DESCRIPTION:
Ltr re our 6-25-73 ltr....furnishing
addl info in support of 100% Thermal
Power Authorization.....W/Attached Figs
1, 2 & 3

PLANT NAME: H. B. Robinson Unit 2

H. B. ROBINSON UNIT NO. 2
LICENSE DPR-23, DOCKET NO. 50-261
ADDITIONAL INFORMATION IN SUPPORT OF
100% THERMAL POWER AUTHORIZATION

FIGURE 1-4

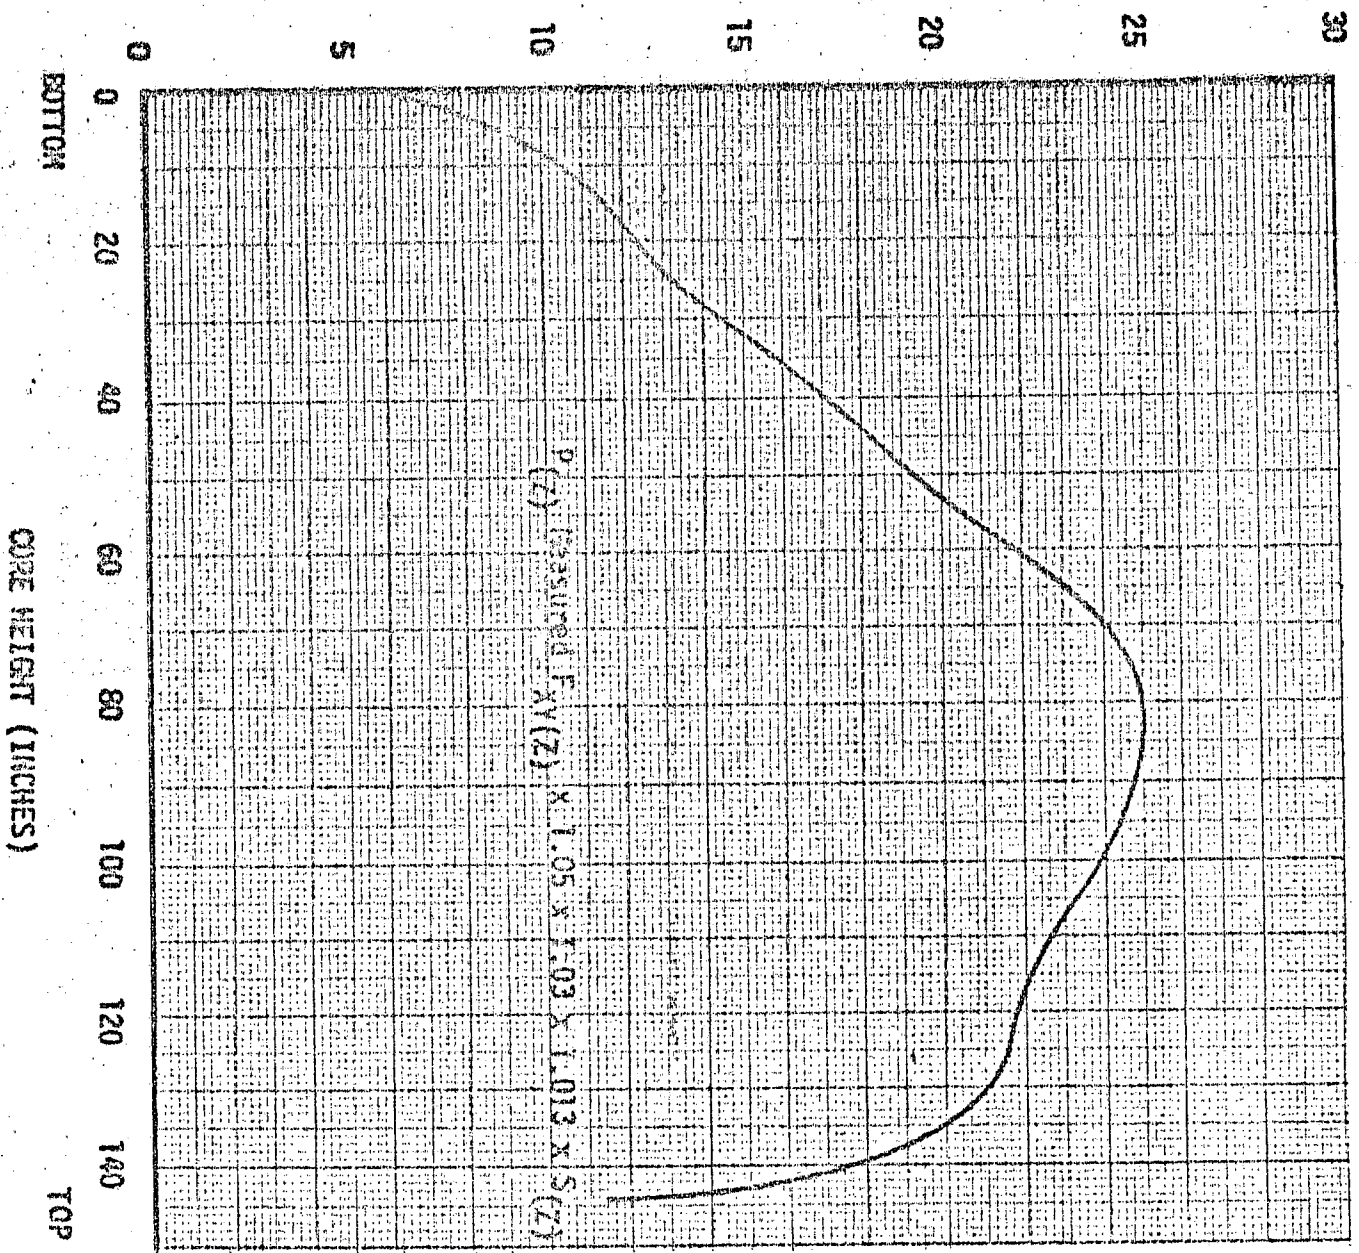
1. Additional analyses have been performed to evaluate the consequences for a LOCA during Cycle 2 operation for various axial power shapes. Specifically, analysis has been performed for an axial power shape representing the "corner point" on the Fq versus axial offset flyspeck plot (refer to Figure 4.2 of WCAP-8114), ie, at the axial offset value beyond which a power reduction is required by the Technical Specification.

The power shape analyzed is shown on Figure 1 as a plot of Fq versus core height. As shown on the figure, allowances have been made for the effect of pellet density variations (1.013) and the power spike penalty appropriate to a region with flattened clad sections. Additionally, the measured values for the radial peaking factor, F_{xy} , as a function of axial height have been included in this figure. The peak linear rod power corresponding to this power shape is 13.8 kw/ft.

FIGURE 2

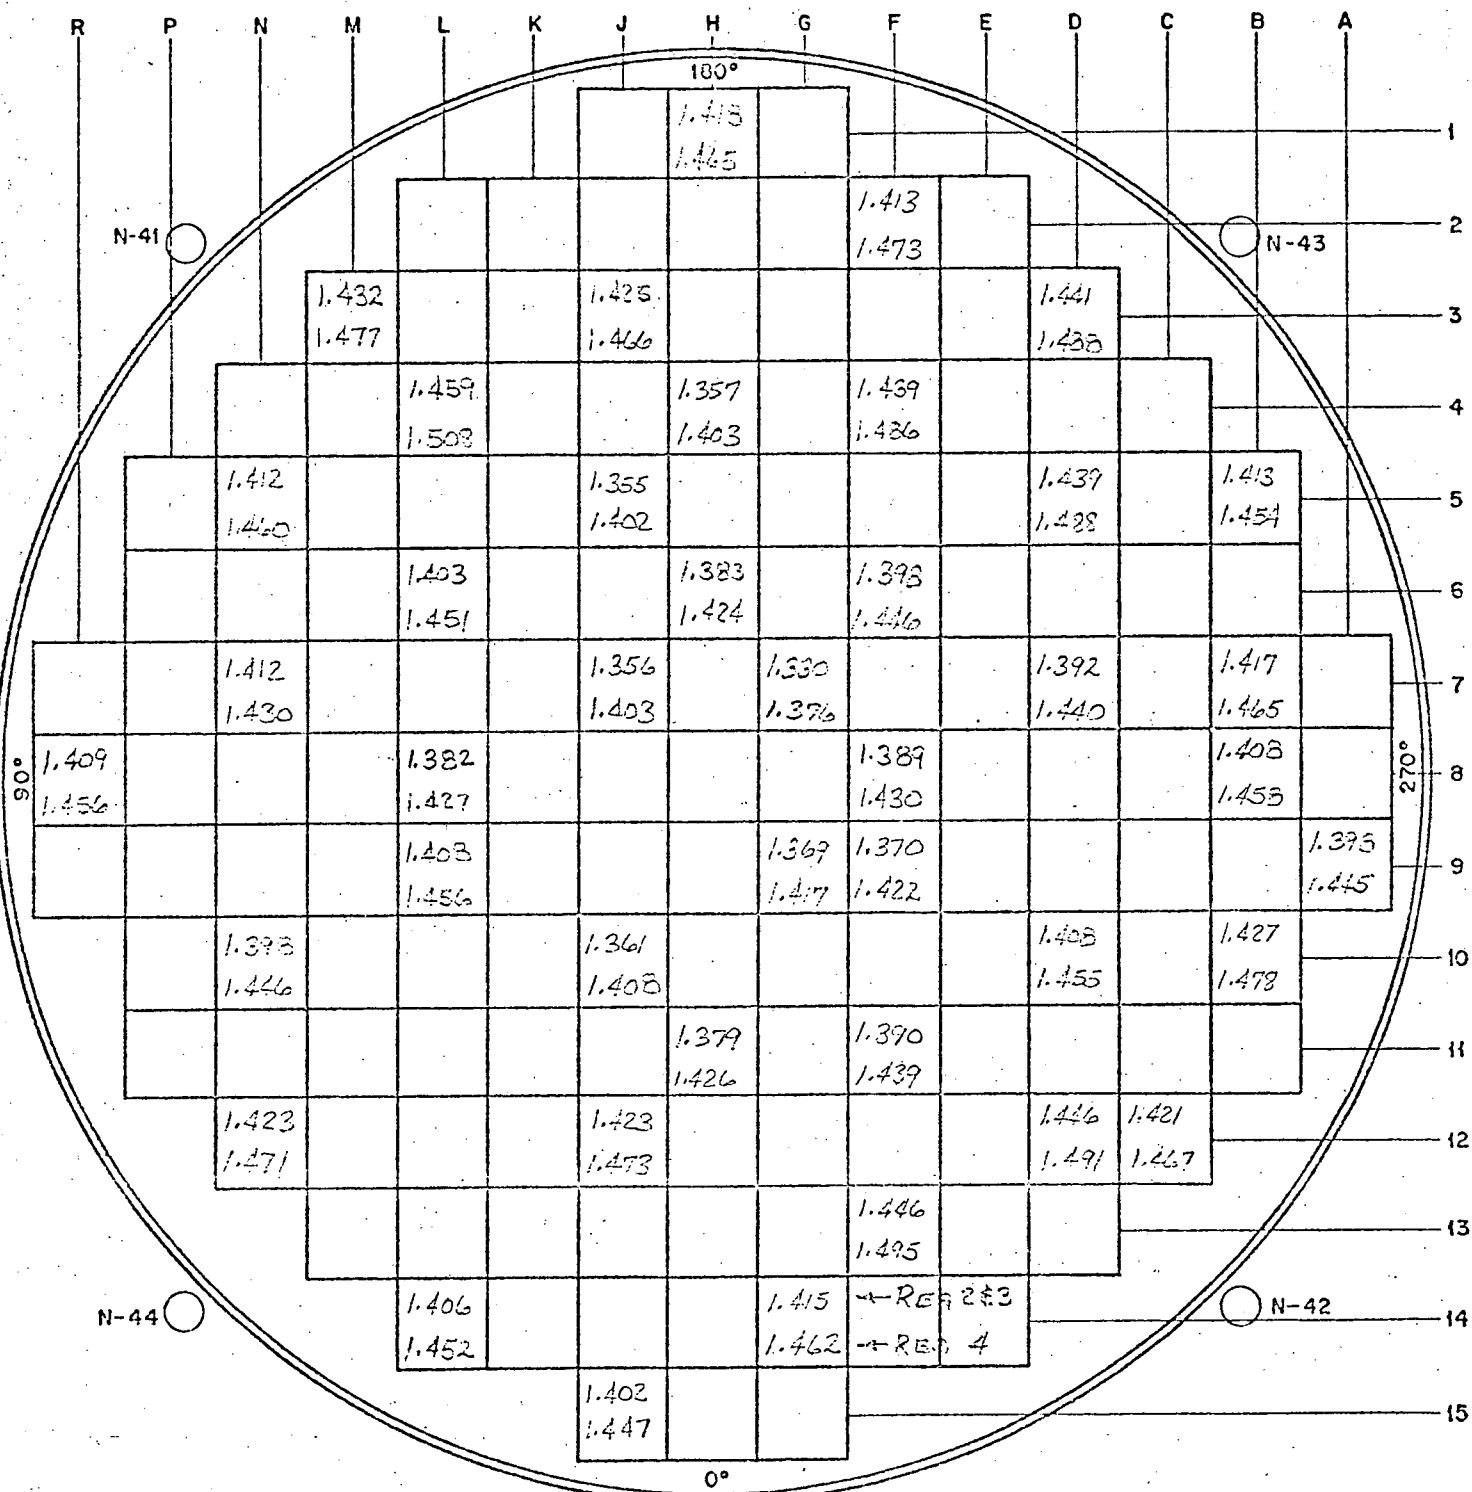
Values of \bar{R} , the factor relating a specific thimble $F_z \cdot S_z$ to the region F_q^N and the associated standard deviation for each \bar{R} were determined and are illustrated in Figures 2 and 3. The values of \bar{R} presented shall serve as the initial values for the conduct of the surveillance program subject to the continued accuracy conditions set forth in 3 above. Likewise the standard deviations contained in Figure 3 serve as the initial bases for thimble selection and the associated uncertainty to be used during surveillance.
